re: Site Servicing Plan Review
Proposed Self Storage Development
75 Michael Cowpland Drive – Ottawa, Ontario

date: September 5, 2023

file: PG3798-MEMO.02 Revision 1

Figure 1 - Typical Rigid Insulation Detail

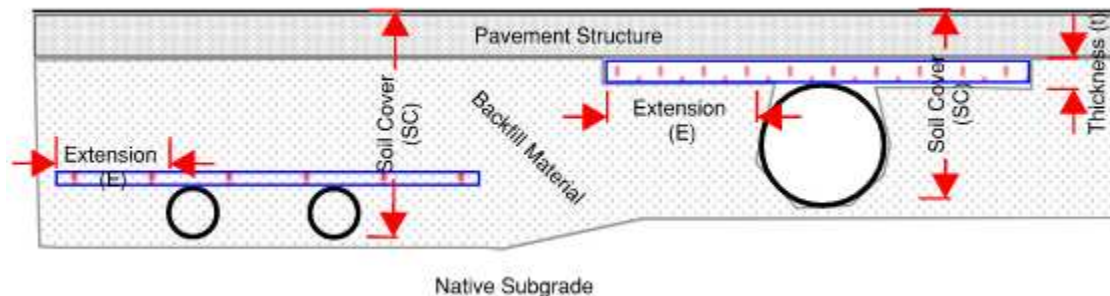
Due to the proposed grading and the addition of the proposed retaining wall, minimal frost cover is provided for the existing service alignments. Therefore, additional frost protection is recommended for these services.

It should be noted that the existing shallow services pipes along the north corner of the site will be subject to insulation due to the new proposed grading at the subject site. Depending on the soil cover above the invert level of the pipes, the following table indicates the minimum thickness of rigid insulation required to be placed directly above the obvert of the subject pipes. A minimum HI-40 rigid insulation panels should be placed directly above the existing pipes and should extend horizontally beyond the edges of the subject pipes as shown on *Figure 1 – Typical Rigid Insulation Detail* below.

The recommended rigid insulation thicknesses based on the available soil cover are shown in Table 1 below.

Table 1 - Rigid Insulation Recommendations for Storm Sewer Pipes with Reduced Soil Cover			
Thermal Condition	Soil Cover Provided (mm)	Insulation Dimensions	
		Thickness (mm)	Extension (mm)
Unheated	600 to 900	125	Extend 1200 mm horizontally beyond edge face of the sewer
	900 to 1200	100	Extend 1200 mm horizontally beyond edge face of the sewer
	1200 to 1500	75	Extend 900 mm horizontally beyond edge face of the sewer
	1500 to 1800	50	Extend 600 mm horizontally beyond edge face of the sewer
	1800 to <2100	25	Extend 300 mm horizontally beyond edge face of the sewer

All rigid insulation should consist of either Dow Chemical High-Load 40 (HI-40) or equivalent other approved by Paterson. The placement of all insulation within the service trenches must be reviewed and approved by Paterson personnel at the time of construction.

PG3798-MEMO.02 REVISION 1 - FIGURE 1 - THICKENED-EDGE SLAB INSULATION DETAILS AND PLAN

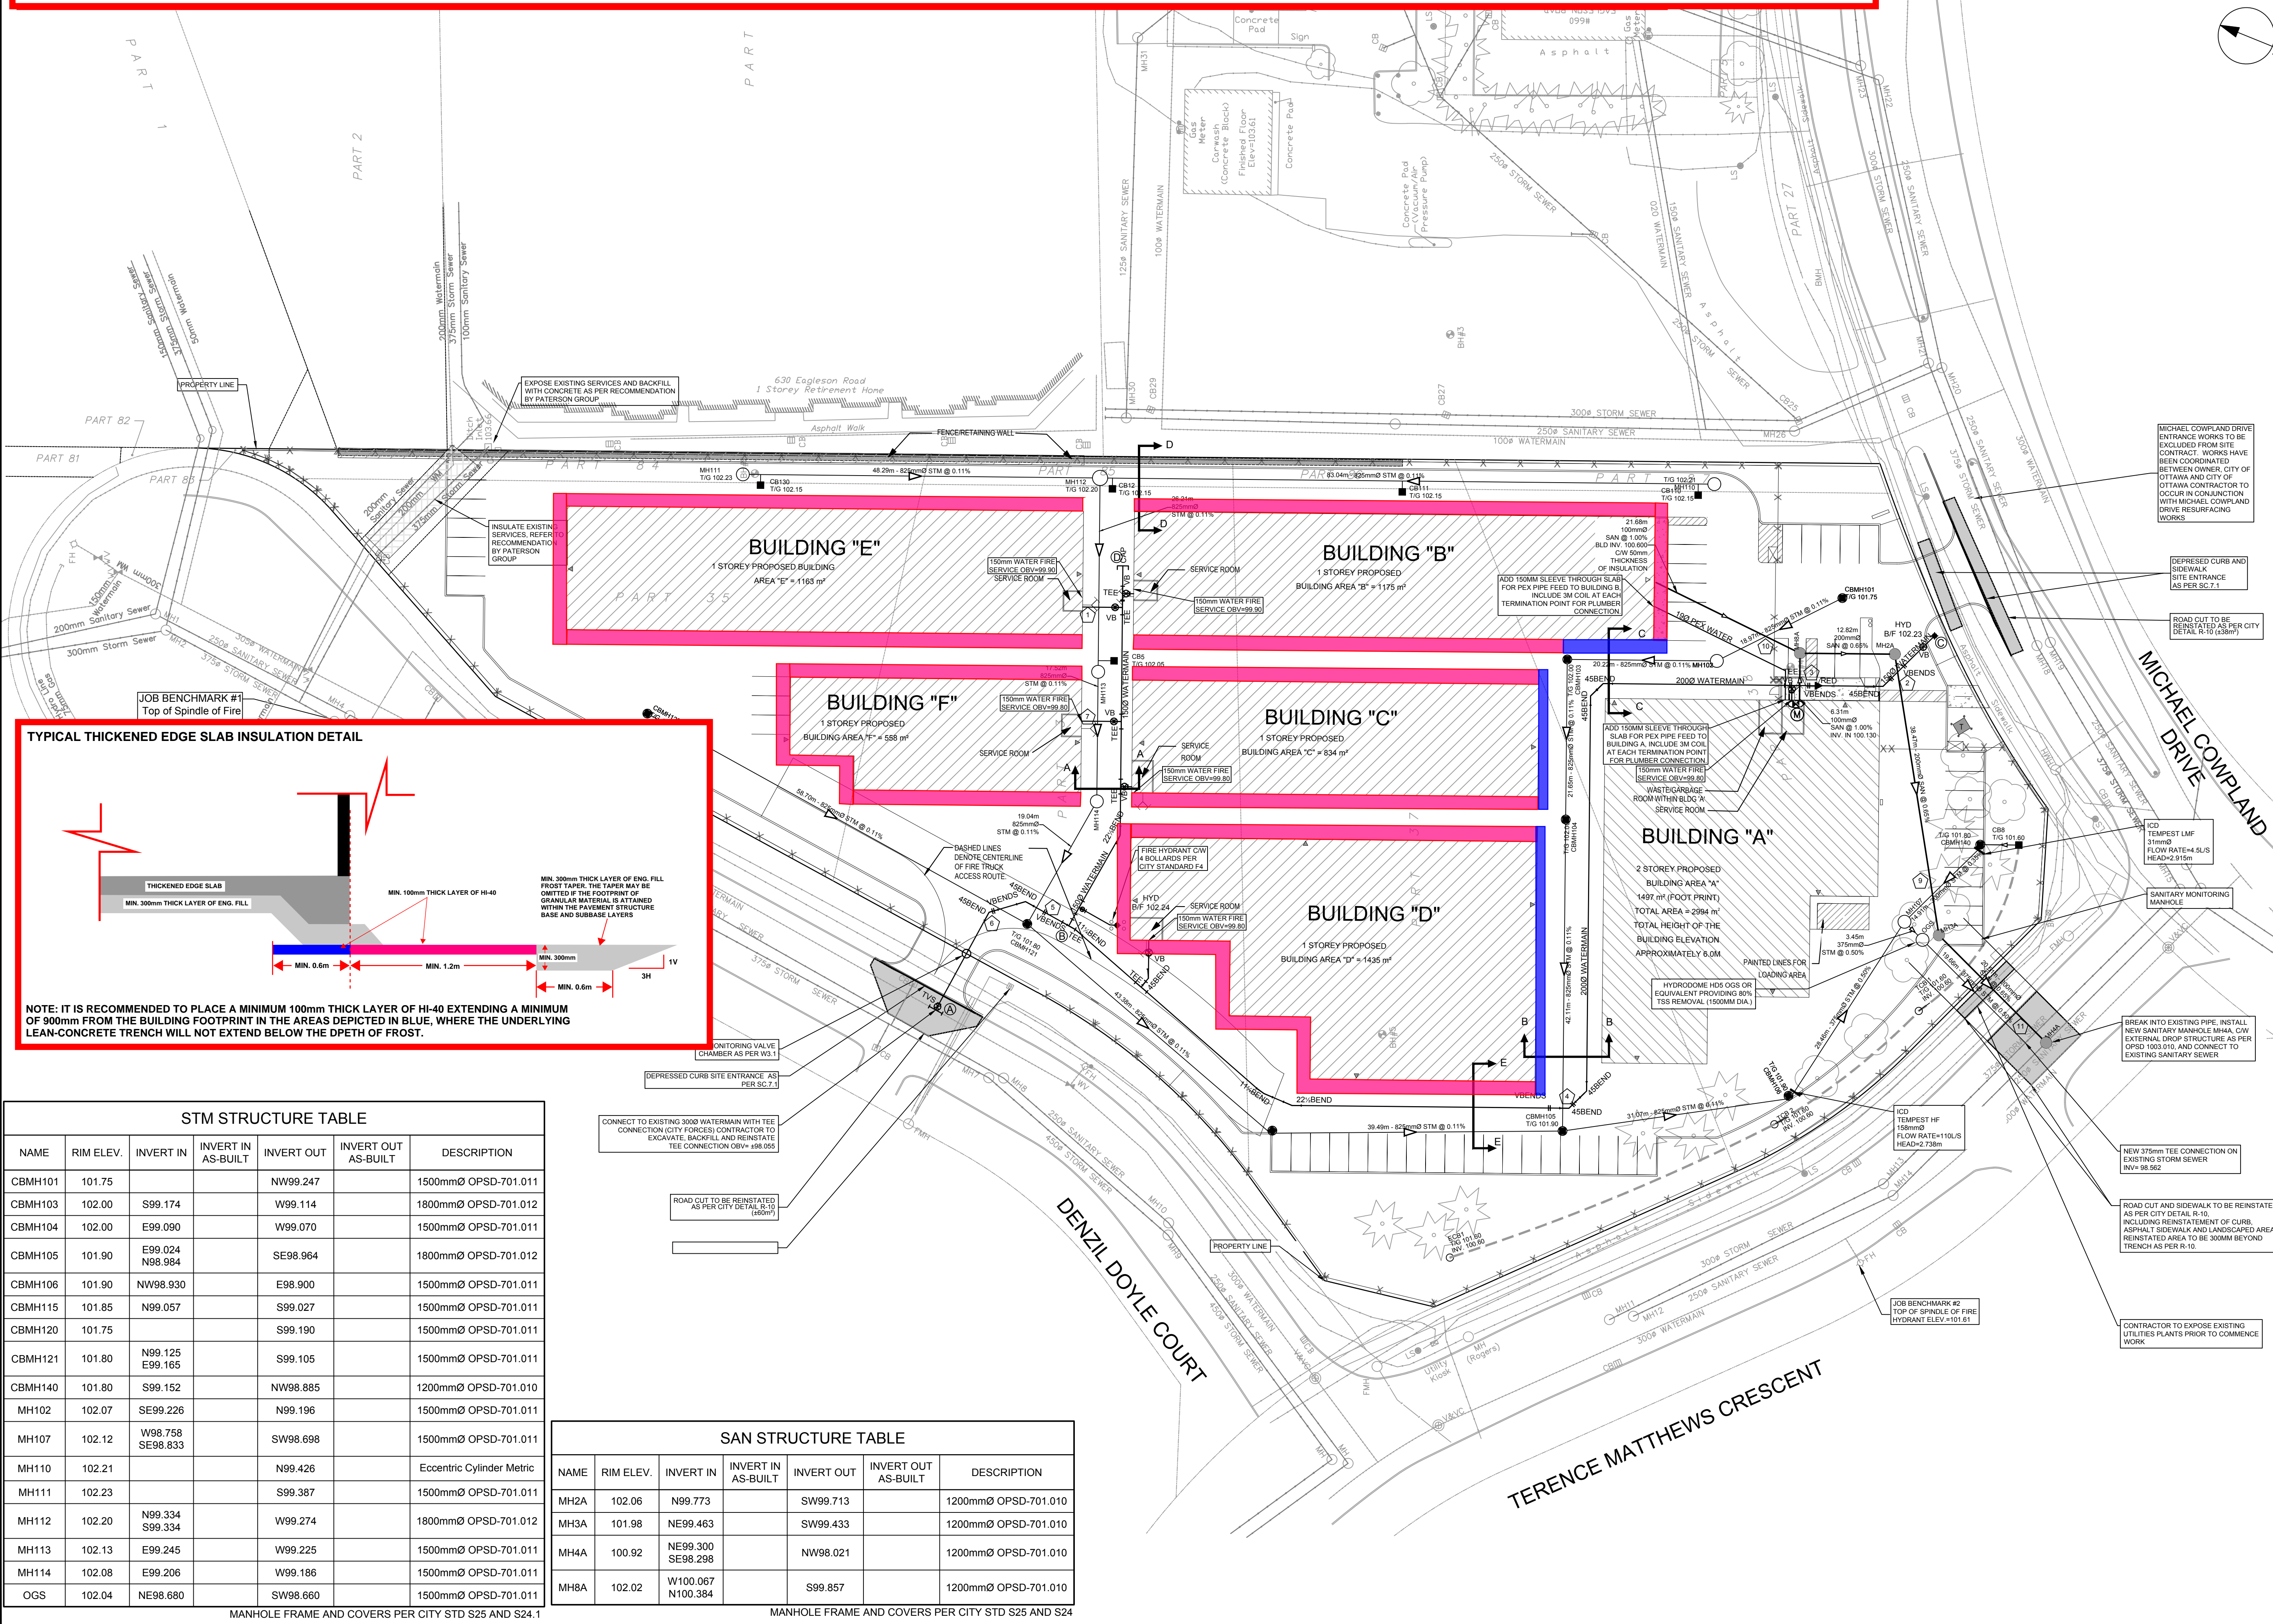
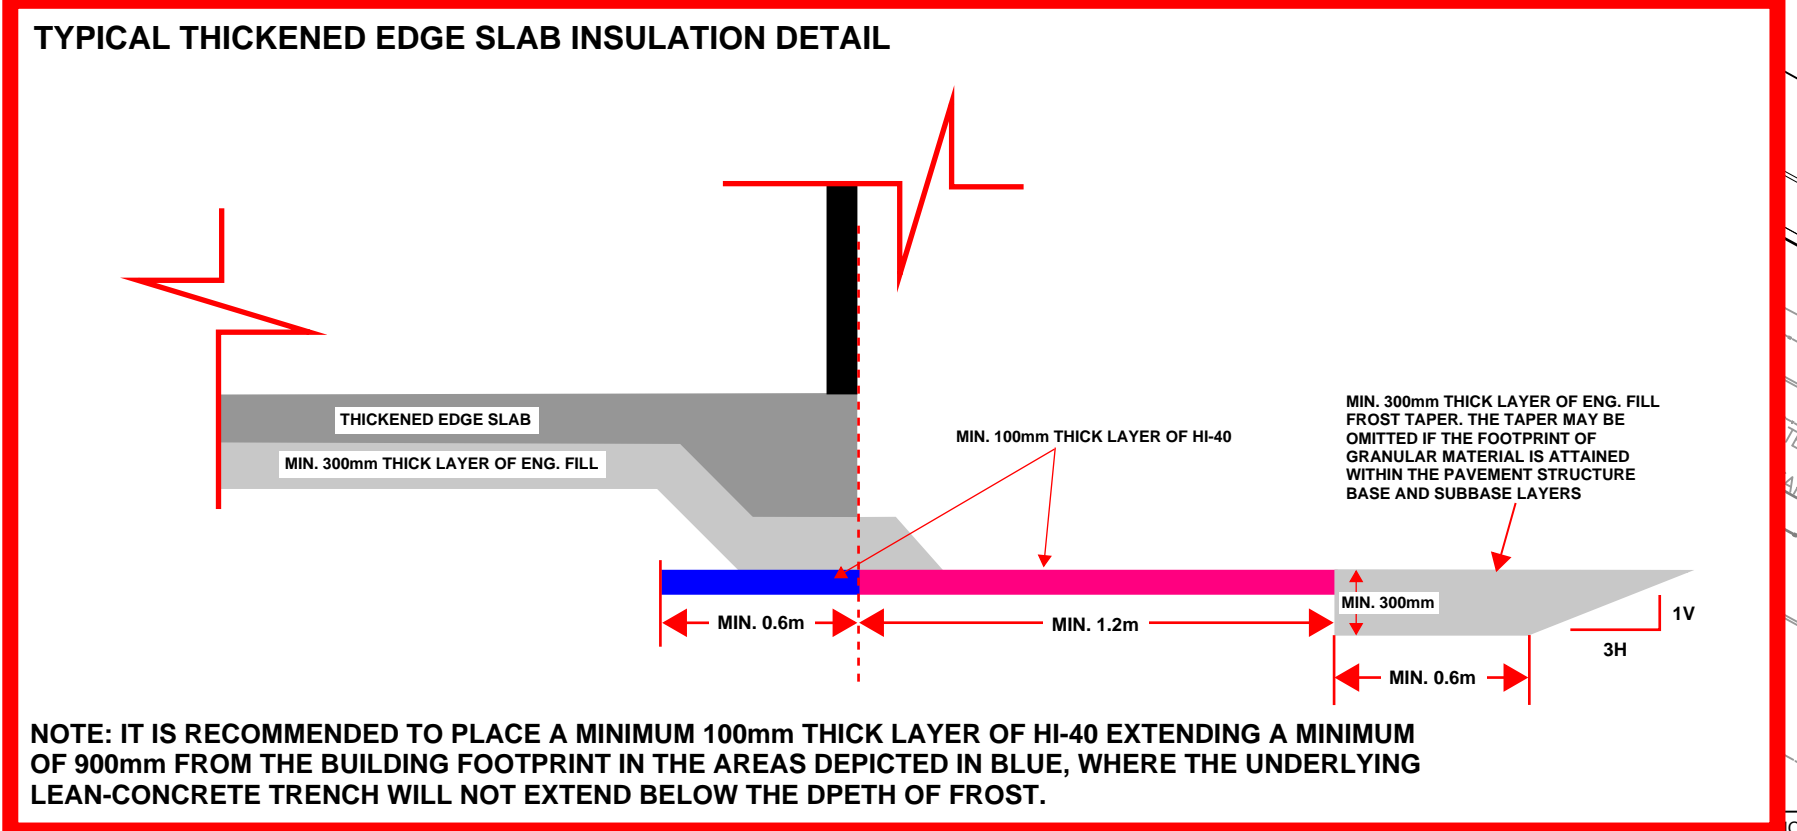
Due to the anticipated depth and proximity of the proposed service pipes to the proposed thickened edge slab footprints, it is expected the lateral support zones for the proposed structures will be negatively impacted by the service installation works. Further, future maintenance that could be considered throughout the proposed service alignments would require trenches that would impact the proposed buildings lateral support zones. Based on this, it is recommended to lower the lateral support zones for thickened edge footings located adjacent to impacting service alignments. This may be accomplished by sub-excavating a near-vertical trench located directly below the overlying footing footprint and in-filled with minimum 17 MPa lean-concrete.

It is recommended the near-vertical trenches extend a minimum of 150 mm horizontally beyond the overlying footing footprint. Based on our review, the lean-concrete trench detail has been incorporated satisfactorily into the above-noted site servicing plans with the exception of widening the trench a minimum of 150 mm beyond the face of the overlying thickened edge footing footprint.

Where the lean-concrete trenches will terminate within the frost zone for a heated building, it is recommended to extend a minimum 100 mm thick layer of HI-40 rigid insulation a minimum horizontal distance of 900 mm beyond the overlying building footprint. The location of this insulation is depicted in blue on *Figure 1 – Thickened Edge Slab Insulation Details and Plan* attached to this memorandum. Where the lean-concrete trench is anticipated to extend below frost zone for a heated building, the exterior building insulation has been omitted from the above-noted plan.

The placement of the lean-concrete trench and rigid insulation should be reviewed and approved by Paterson personnel at the time of construction.
